Cupola Roof

OD Projects

CHECKED BY: Approval DRAWING NUMBER: 4394-01-001

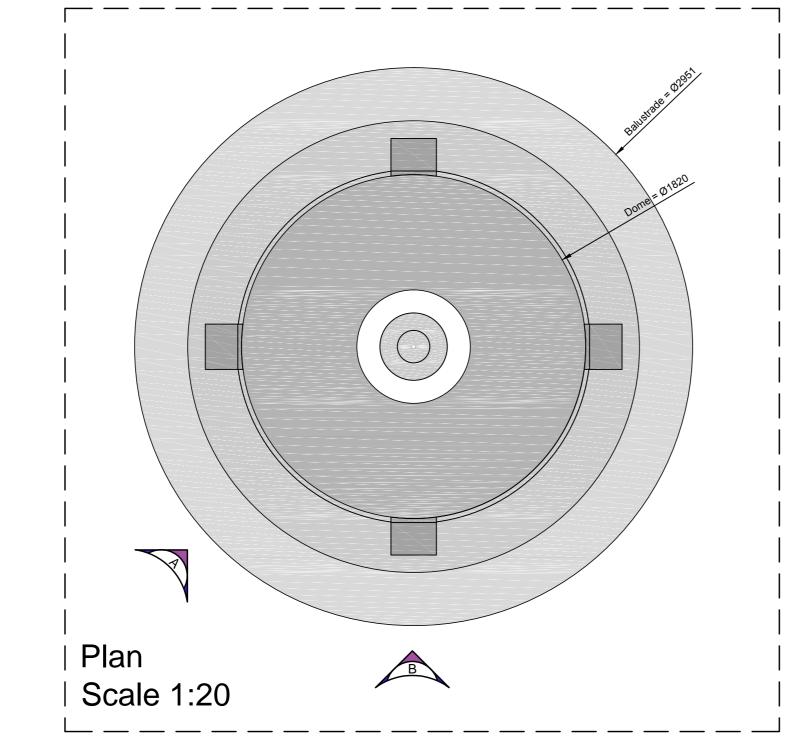
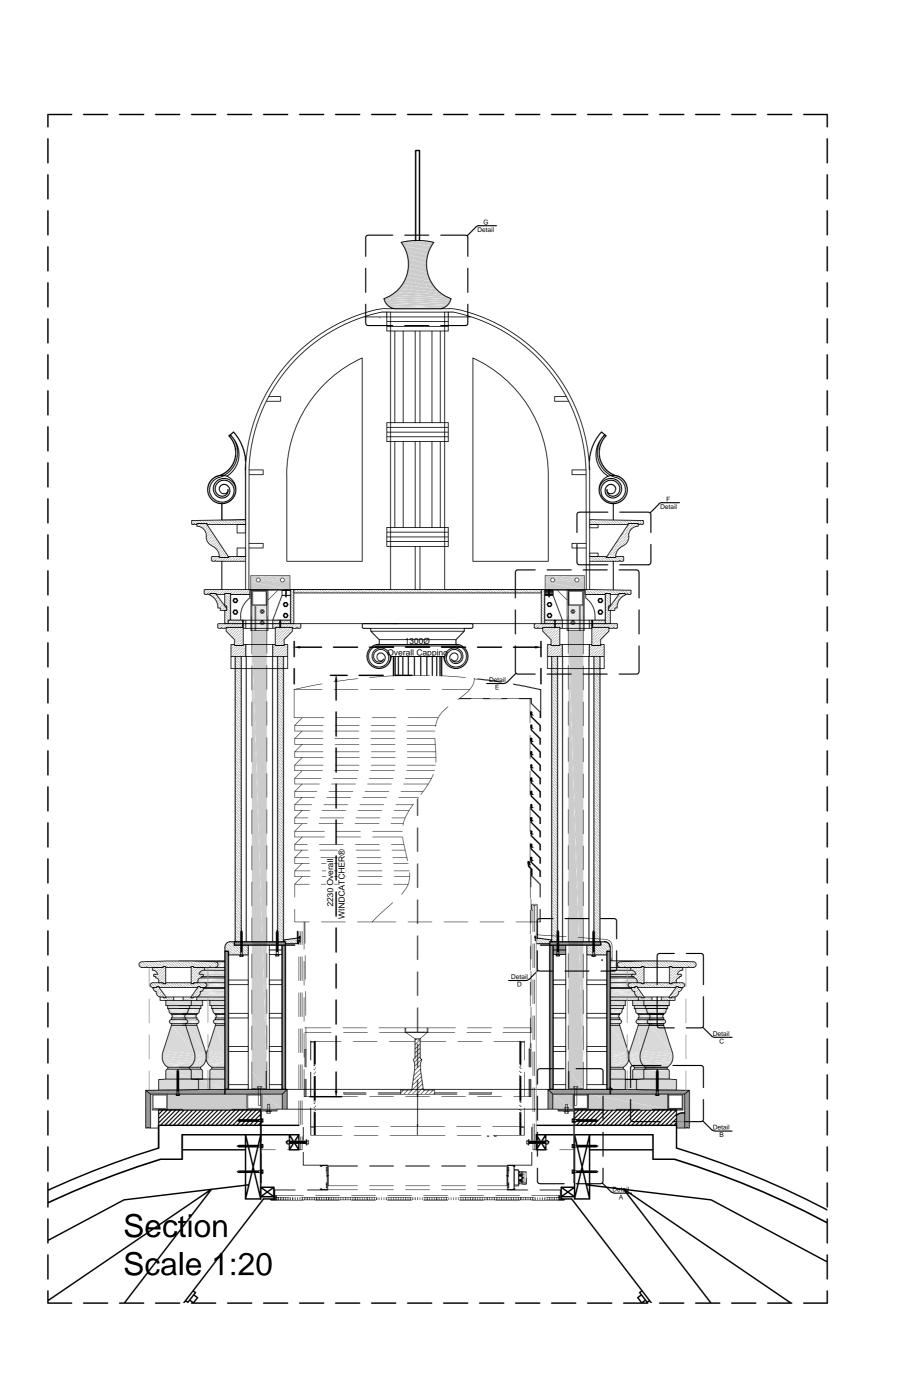
Rev B.
Revised to suit comments from Ted Bogal regarding fitment of Monodraught windcatcher, scrolled column tops spun 90 deg, 80mm build up included ref Ted Bogal info, extra metalwork details included.

Revised to suit comments received and extra details added.
